Maxtor Corporation
500 McCarthy Boulevard
Milpitas, CA 95035 USA

To: T10 Parallel SCSI Working Group
From: Russ Brown
Email: russ_brown@maxtor.com
Date: 22 February 2002

Subject: Proposal for Offset Correction for Ultra640 SCSI for SPI-5

Figure A.y - Input Signal Offset Component $V_{RXOFFSET}$

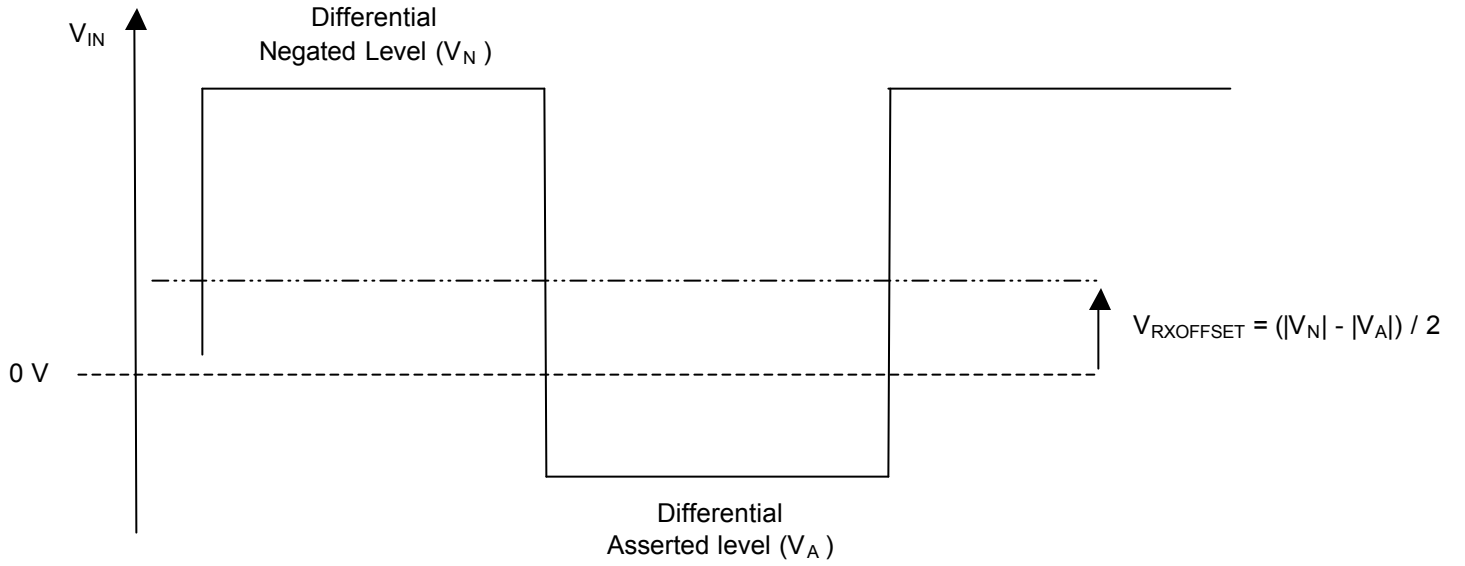
Make the text in the existing clause into subclause A.3.2.1 Steady state input voltage requirements for Fast160 and slower LVD receivers, and, add subclause A.3.2.2 Steady state input voltage requirements for Fast320 LVD receivers. The content for this new subclause is as follows:

A.3.2.2 Steady state input voltage requirements for Fast320 LVD receivers

Table A.x and Figure A.y define the voltages for the requirements in this subclause.

The differential offset component of the receiver input voltage is defined as:

$$V_{RXOFFSET} = (|V_N| - |V_A|) / 2$$

where $|V_A|$ and $|V_N|$ are the steady state differential Asserted and Negated signal levels applied to the receiver, measured after 100 ns assertion (negation) of the signal.

Within the common-mode input voltage range (V_{CM}), of $0,845 \text{ V} < V_{CM} < 1,655 \text{ V}$ (see table A.7) and after calibration on a training pattern containing a differential offset voltage component, $V_{RXOFFSET}$, a Fast320 receiver shall detect assertion and negation with V_{IN} in the ranges shown in Table A.x, and over an input signal offset range of $-75 \text{ mV} < V_{RXOFFSET} < +75 \text{ mV}$ (see figure A.11 for the test circuit for V_{IN}).
